City Hall/Town Hall

December 7, 2015

Del Mar City Council

Project Status

Parking Access – Alt. 1 & 2

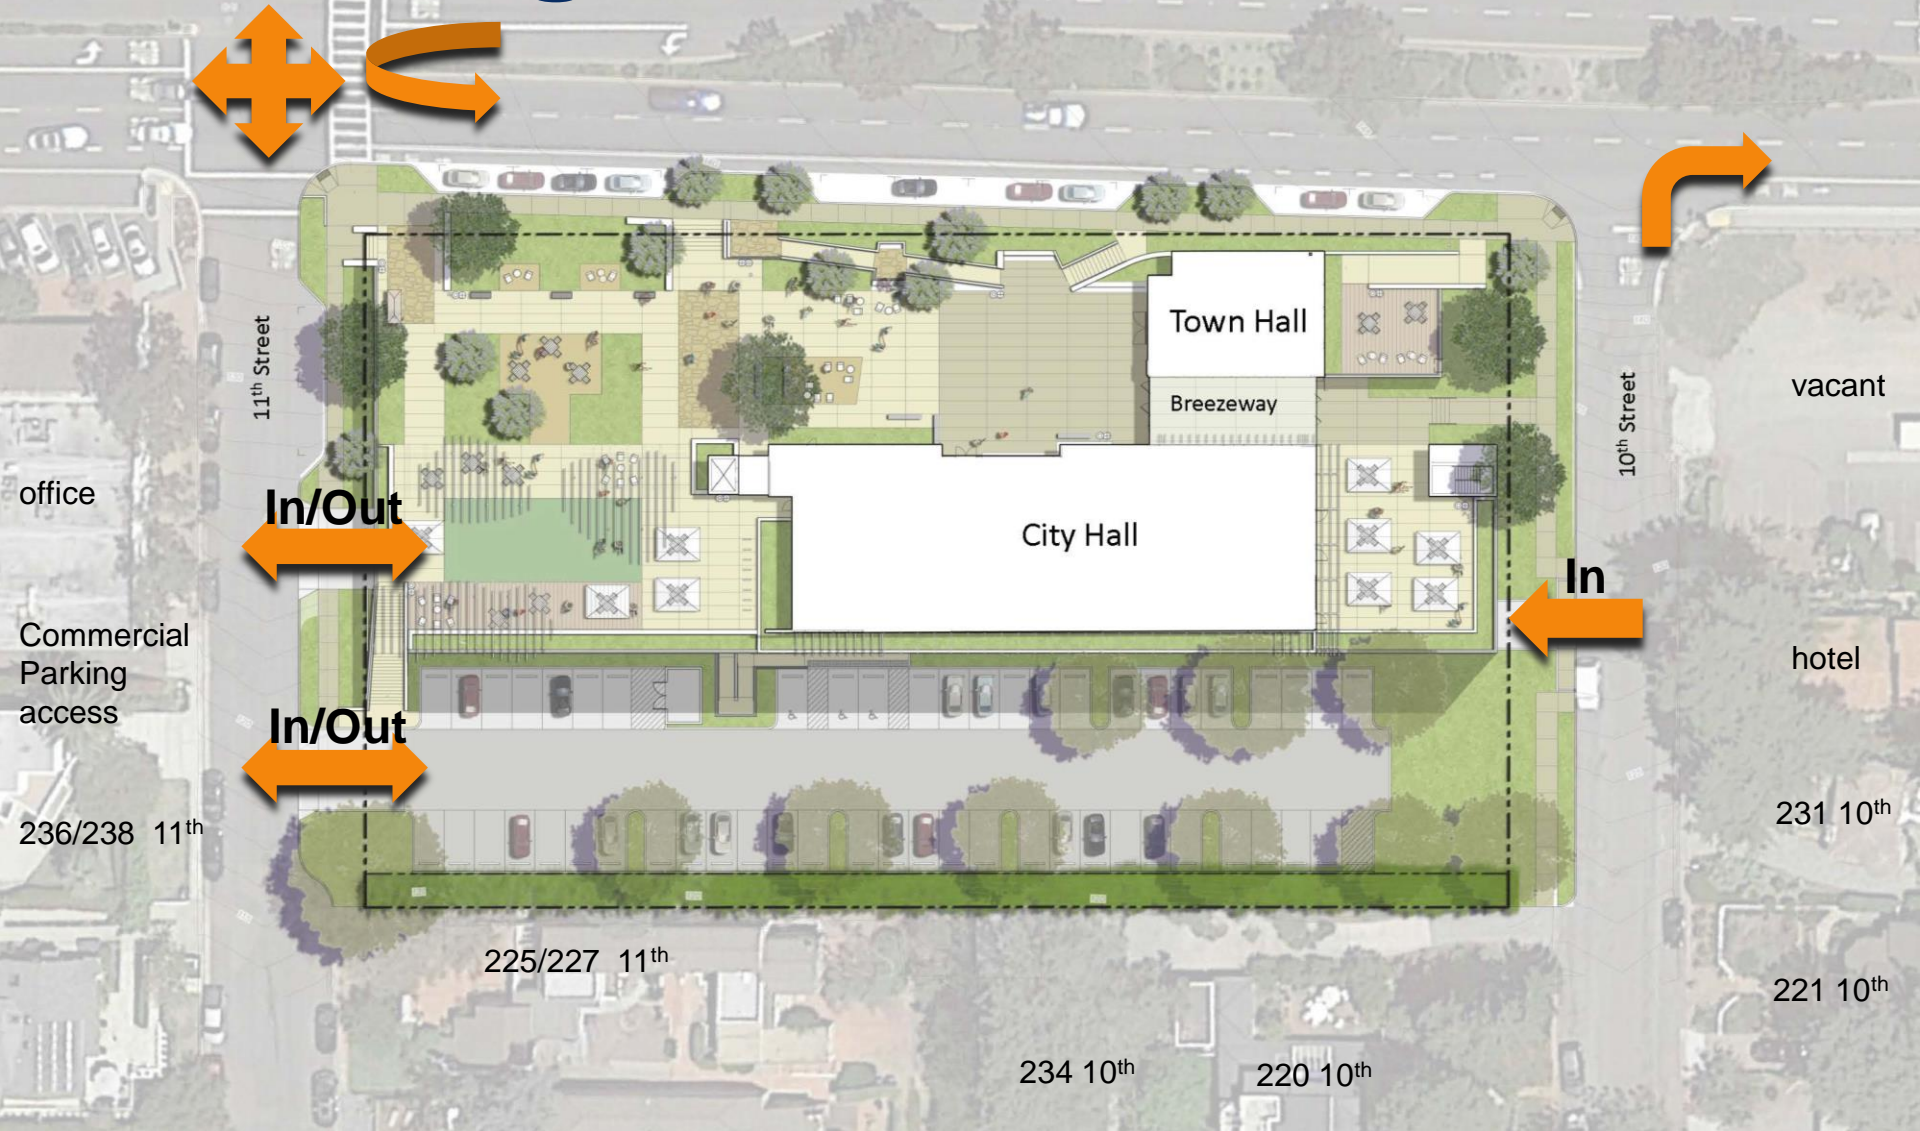
1. Install signage on all egress for right turn only to CDM or
2. Install diverter to force right turns from garage to CDM

Parking Access – Alt. 3

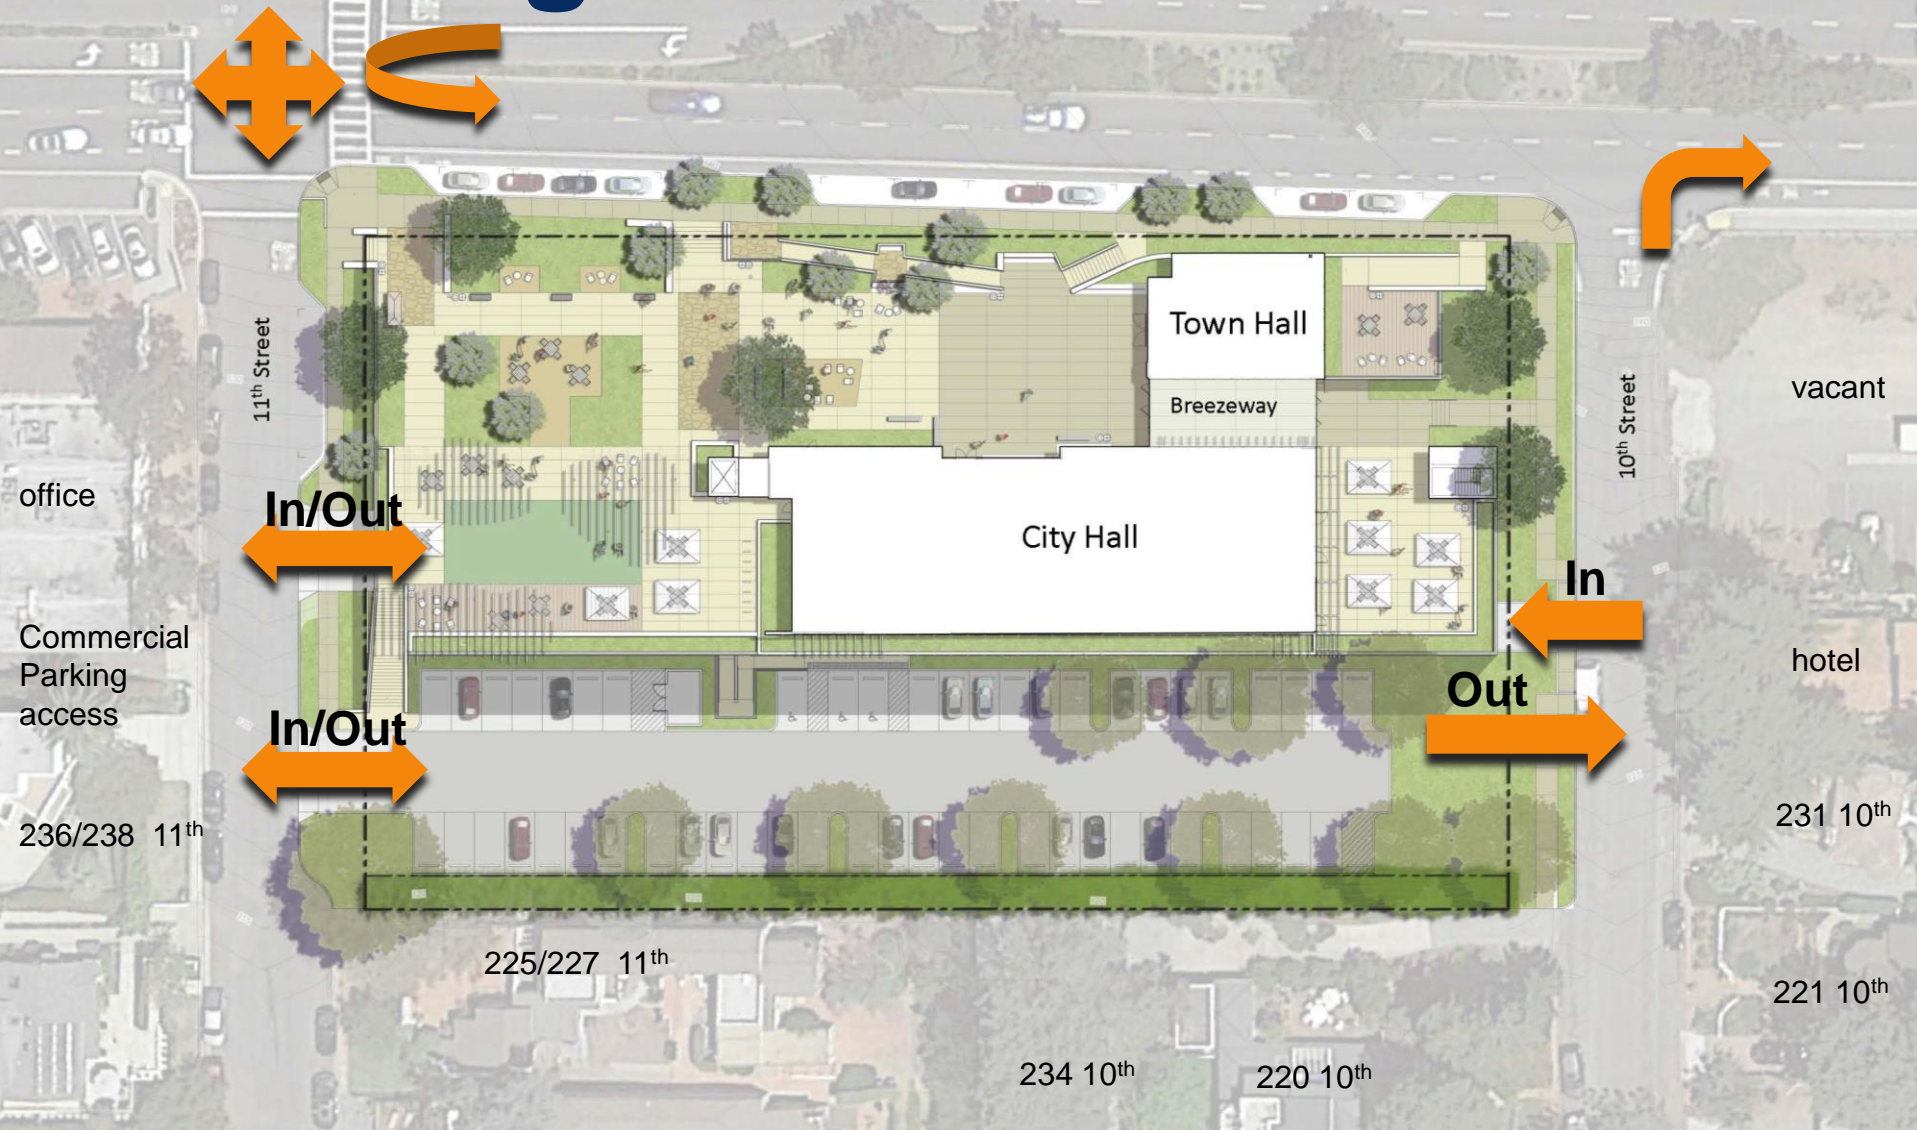
10th Street: Garage ingress only, surface lot egress only

11th Street: Garage ingress/egress; surface lot ingress/egress

Parking Access – Alt. 4A

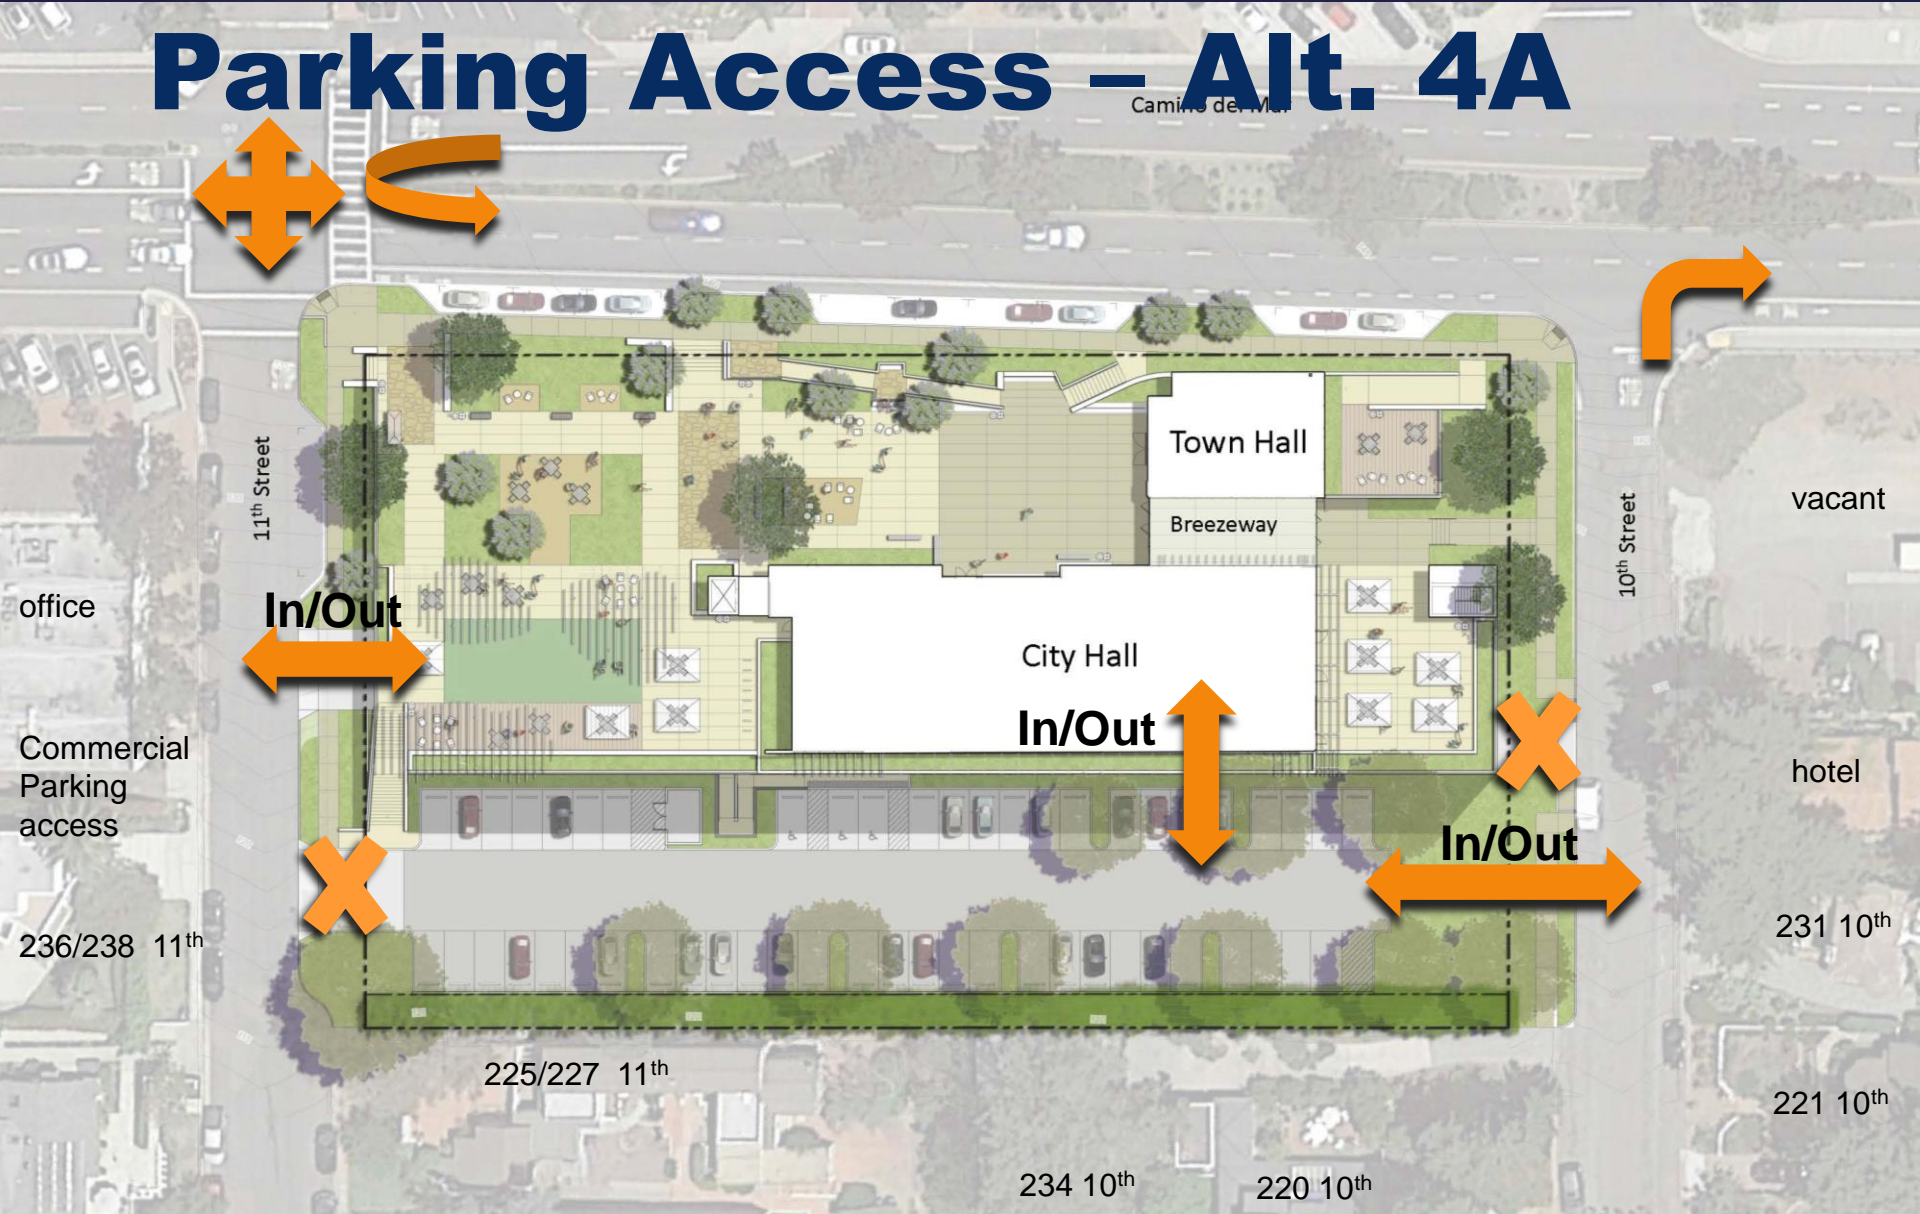
10th Street: Surface lot ingress/egress

11th Street: Garage ingress/egress; possible internal connection

Parking Access – Alt. 4B

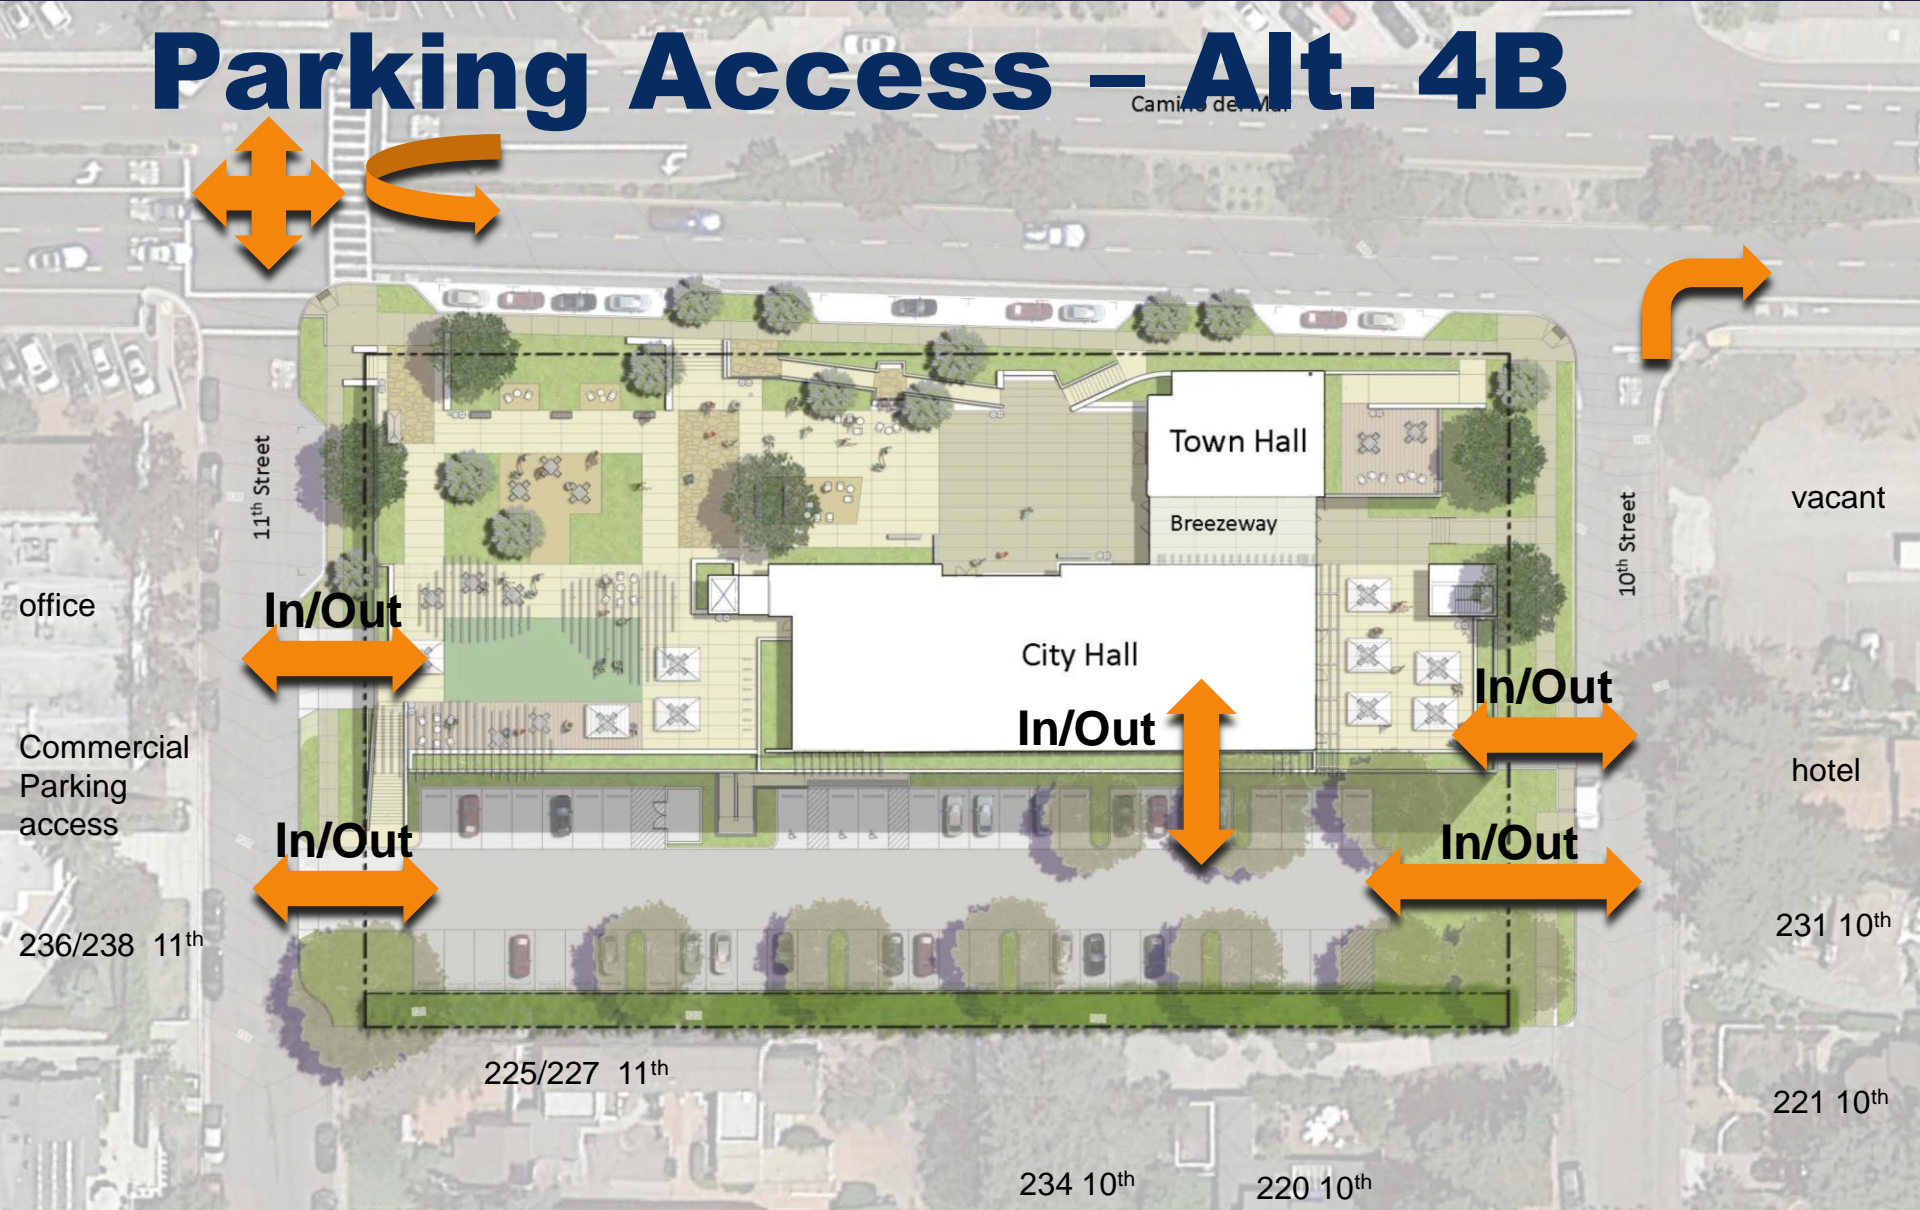
10th Street: Garage and Surface lot ingress/egress
11th Street: Garage and lot ingress/egress; possible internal connection

Parking Access – Alt. 4C

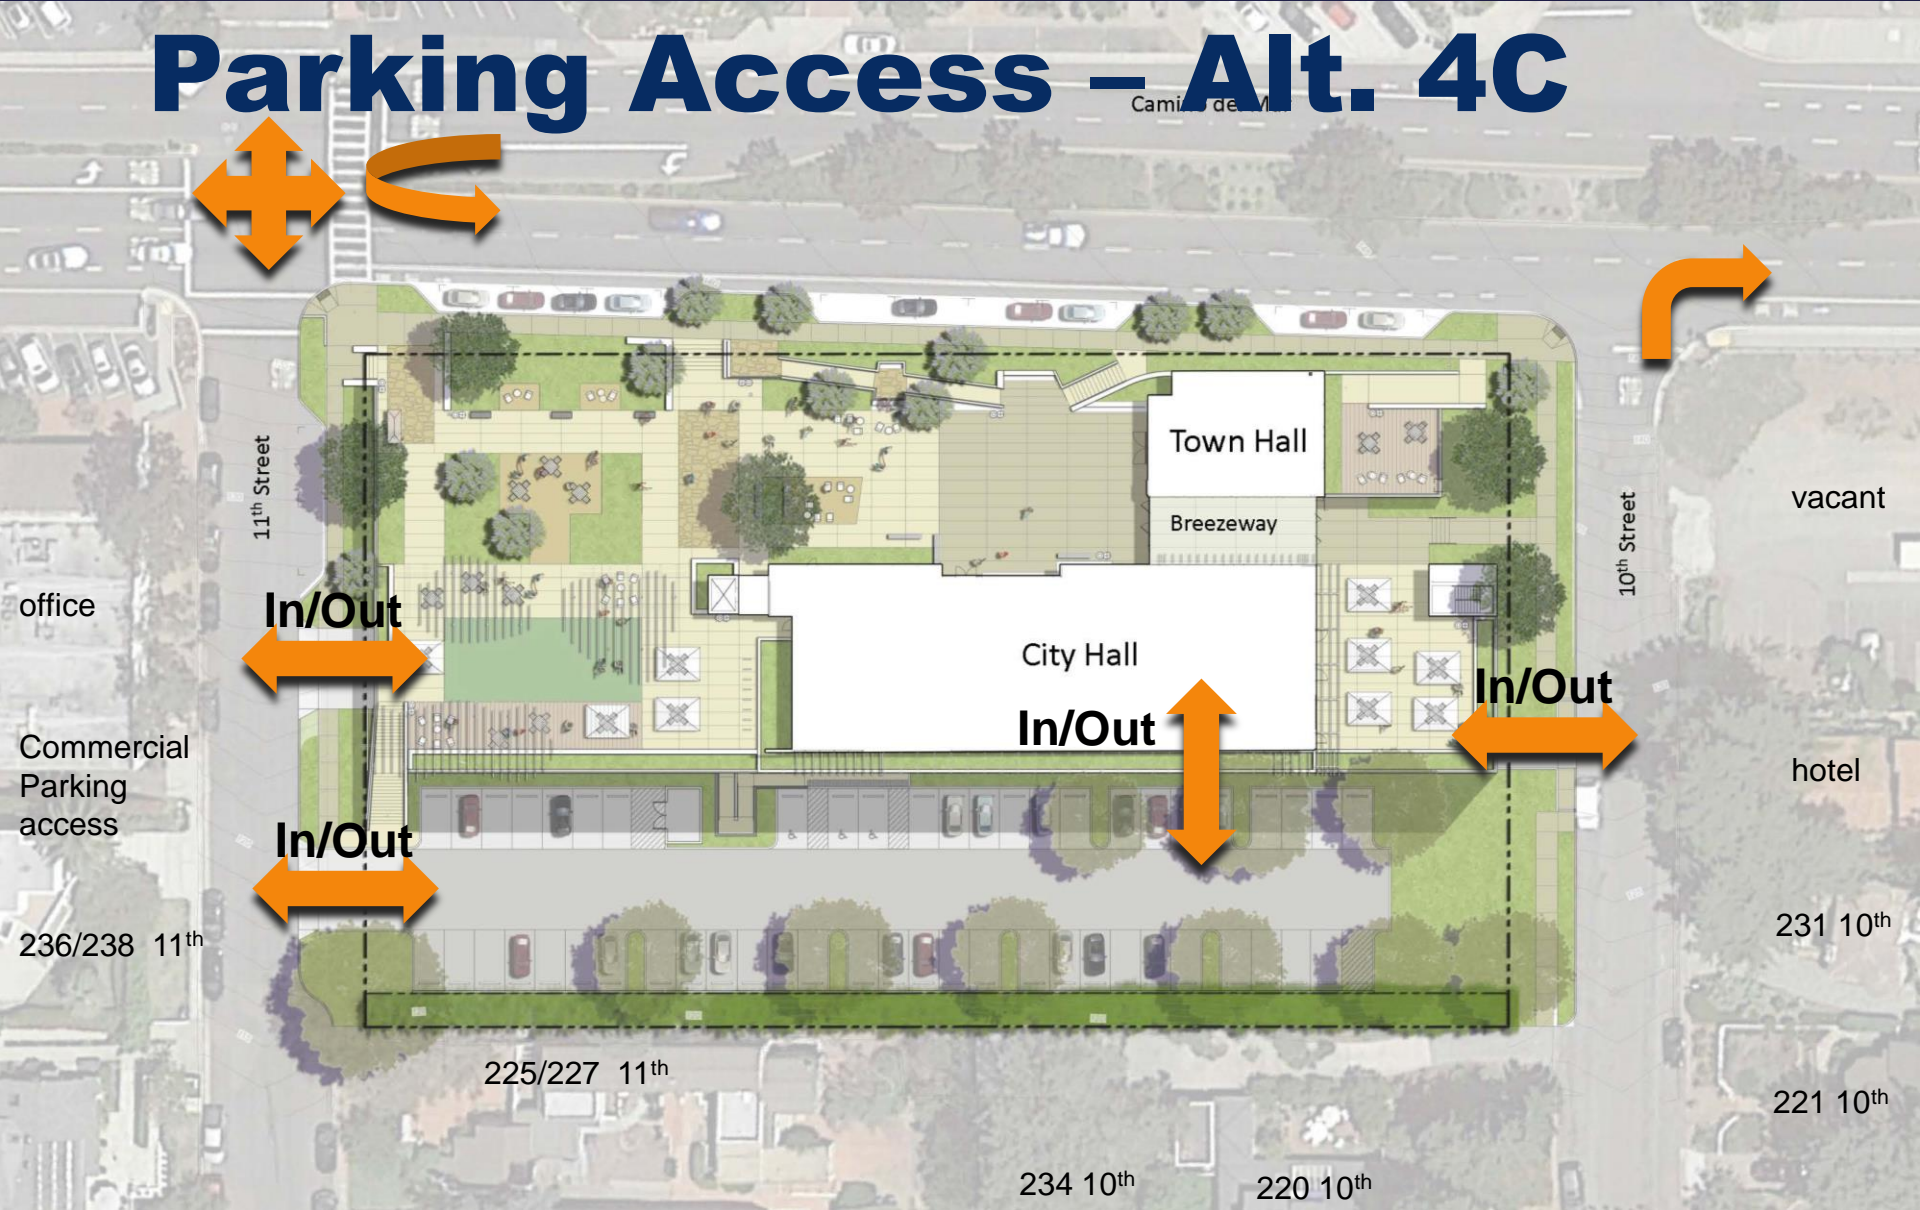
10th Street: Garage ingress/egress
11th Street: Garage and surface lot ingress/egress; possible internal connection
